DESCRIPTION:
AXLE TRSN NB 3700# 70.25"FC
AIR TIGHT

PART #:
300-034277

ECN:
897

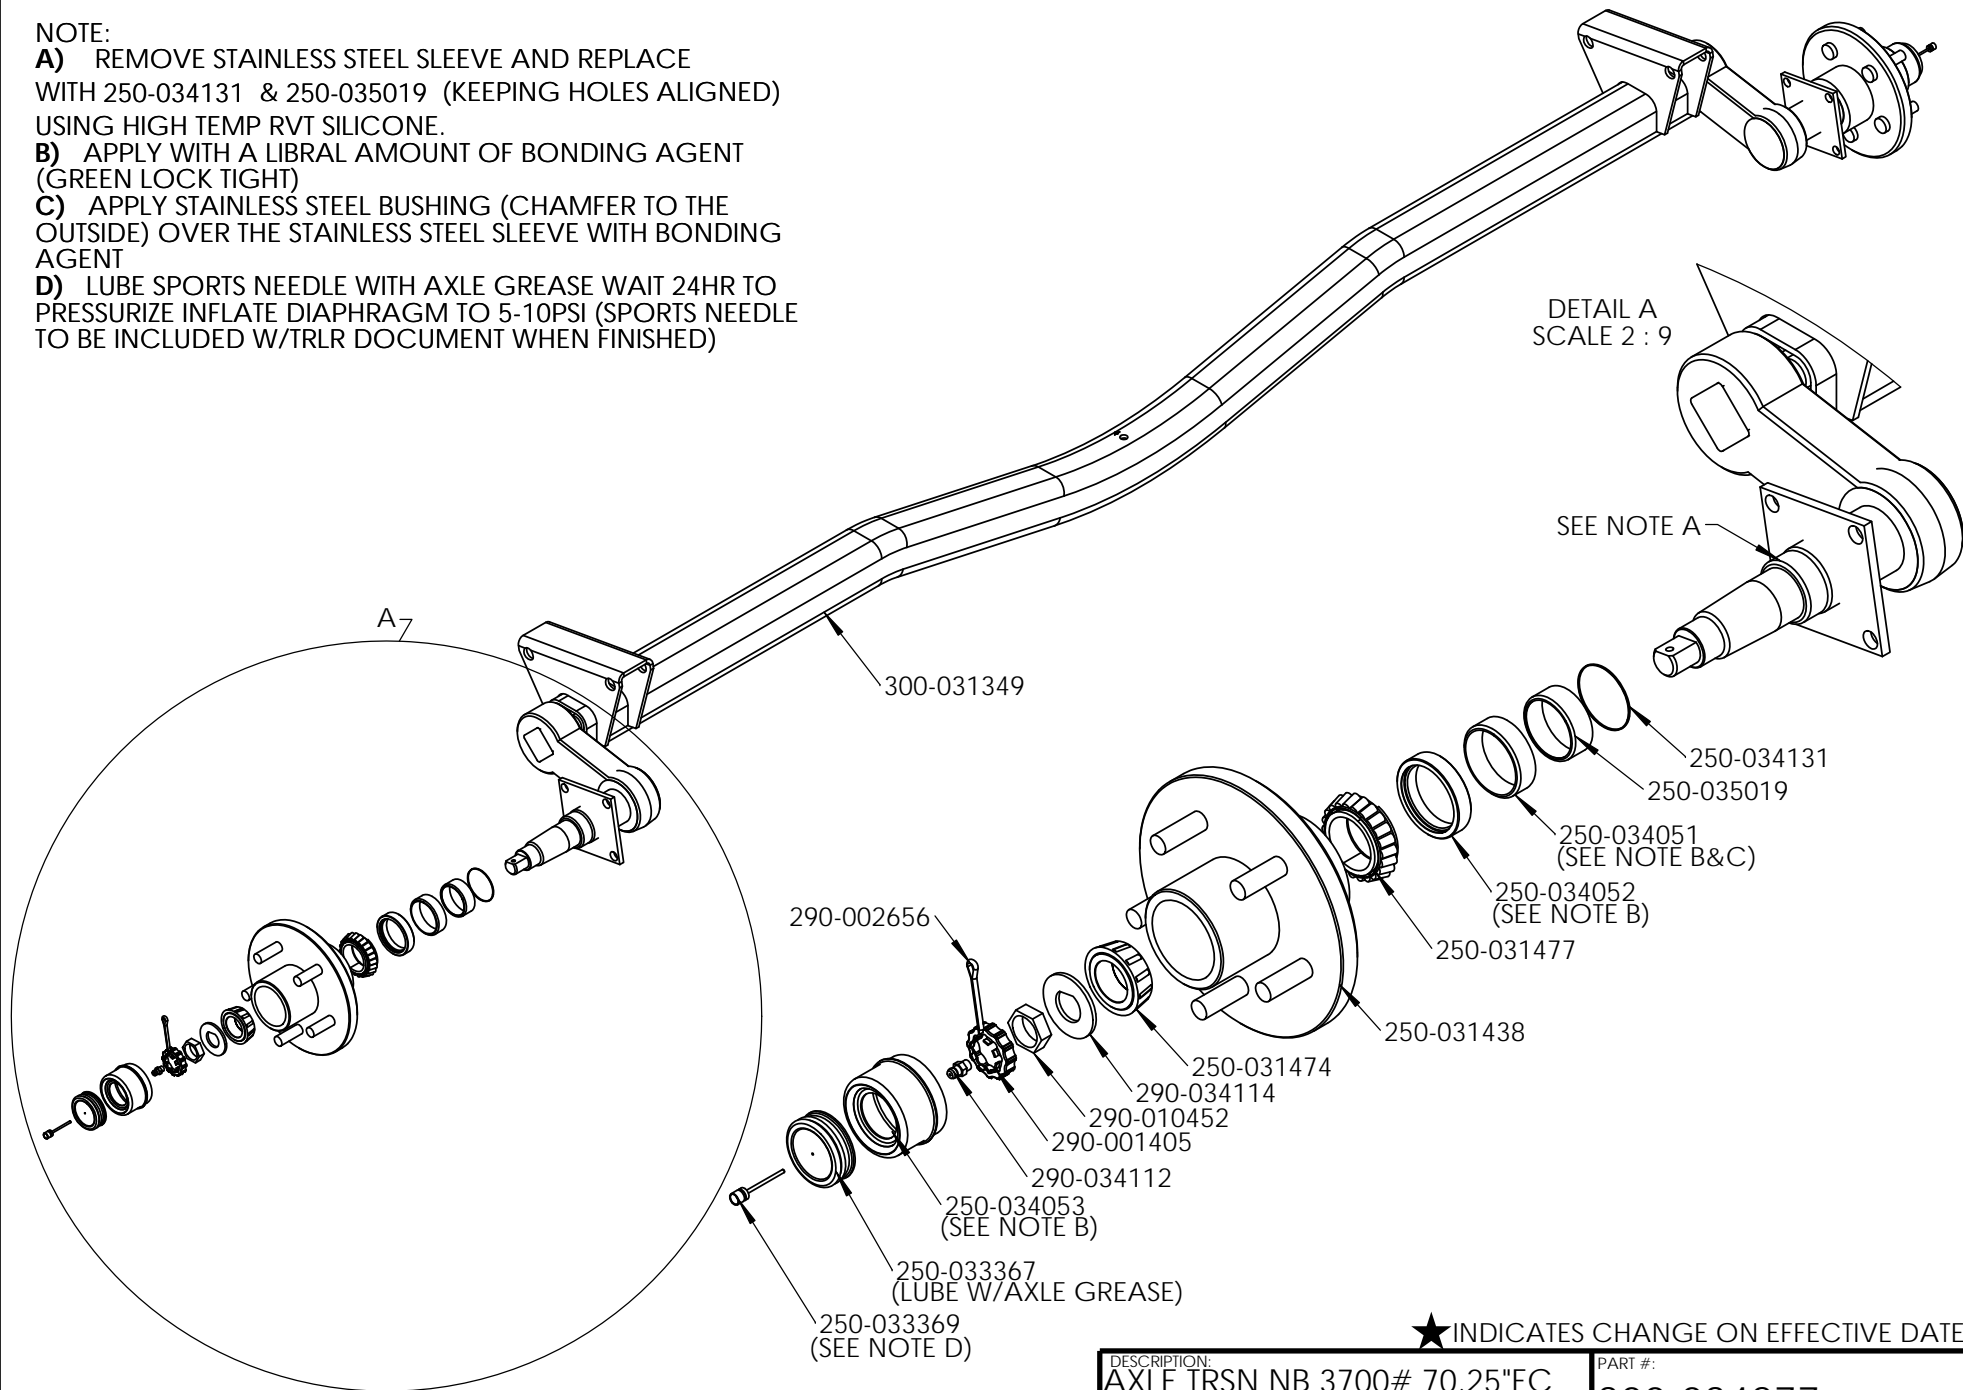
A) REMOVE STAINLESS STEEL SLEEVE AND REPLACE WITH 250-034131 & 250-035019 (KEEPING HOLES ALIGNED) USING HIGH TEMP RVT SILICONE.

B) APPLY WITH A LIBRAL AMOUNT OF BONDING AGENT (GREEN LOCK TIGHT)

C) APPLY STAINLESS STEEL BUSHING (CHAMFER TO THE OUTSIDE) OVER THE STAINLESS STEEL SLEEVE WITH BONDING AGENT

D) LUBE SPORTS NEEDLE WITH AXLE GREASE WAIT 24HR TO PRESSURIZE INFLATE DIAPHRAGM TO 5-10PSI (SPORTS NEEDLE TO BE INCLUDED W/TLR DOCUMENT WHEN FINISHED)
